The authors would like to thank the Anonymous Referee #2 for their detailed review of our paper and the many constructive and interesting comments. We believe they will enhance the document significantly. In the following, we provide our answers. The reviewer comments are printed in black, and our replies, in blue.

RC2: Anonymous Referee #2

Figure 7. Relative bias (BIAS) and MCRPS of the ensemble streamflow forecasts of the four hydrological prediction systems and lead times 1, 3, and 6 days when considering raw (blue) and post-processed (red) precipitation forecasts. Boxplots represent the score variability over the 30 catchments.

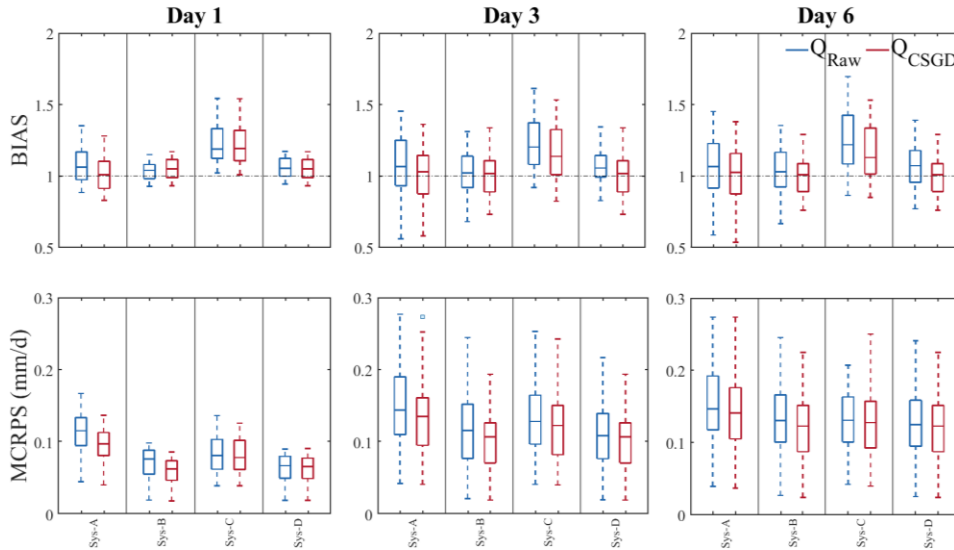
iii) Figs 11-14 could be combined into a single figure. At the very least, I suggest Figs 13 & 14 should be combined - as the authors note, sharpness without reliability is meaningless.

AR: We thank the reviewer for the suggestion. We will use the following figures in the revised version:

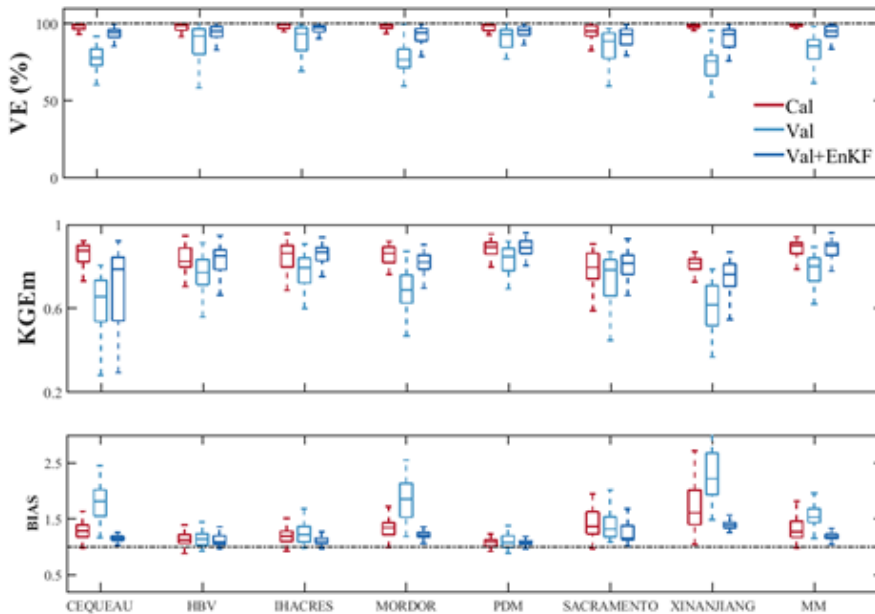
10. **RC2:** L333-334 "Accordingly, we decided to use the reliability diagram to evaluate precipitation for thresholds of different exceedance probabilities (EP), namely 0.05, 0.5, 0.75, and 0.95". Could the authors please confirm 1) that to construct the reliability diagrams, they have converted probabilistic forecasts to binary predictions for exceeding thresholds based on these quantiles and 2) these quantiles are taken from observations and 3) that they have calculated MAE_{rd} across all these thresholds? These things weren't entirely clear to me from the description. L338 IQR (interquartile range) usually denotes the range between two quartiles (25thile and 75thile). So

'IQR' is not the correct term to use for a different interval. Suggest using the term 'average width of prediction interval' (AWPI).

3) No, we just used those quantiles for Figure 10. To compute the MAErd, we calculate nine confidence intervals with nominal confidence level of 10–90%, with an increment of 10% for each emitted forecast. Then, it was established whether or not each confidence interval covered the observation for each forecast and each confidence interval. This was repeated for all the forecast–observation pairs. In a well-calibrated distribution, the observation inside each confidence interval and its corresponding nominal confidence level should be close, taking the form of a linear relationship 1:1 (as the reliability diagram). Finally, the difference between these values is equivalent to the MAE of the reliability diagram. In this way, we treat the forecasts as continuous variables.

In L338 it was a typo error. The correct word is Interquantile, as shown in Figure 4. We used the 90% Interquantile range, the difference between the 95th quantile and the 5th quantile (Gneiting et al. 2007) that have been used widely as a metric to evaluate the sharpness in the hydrometeorological forecasting community (Cassagnole et al. 2021, Bourgin et al. 2014, Crochemore et al., 2016).
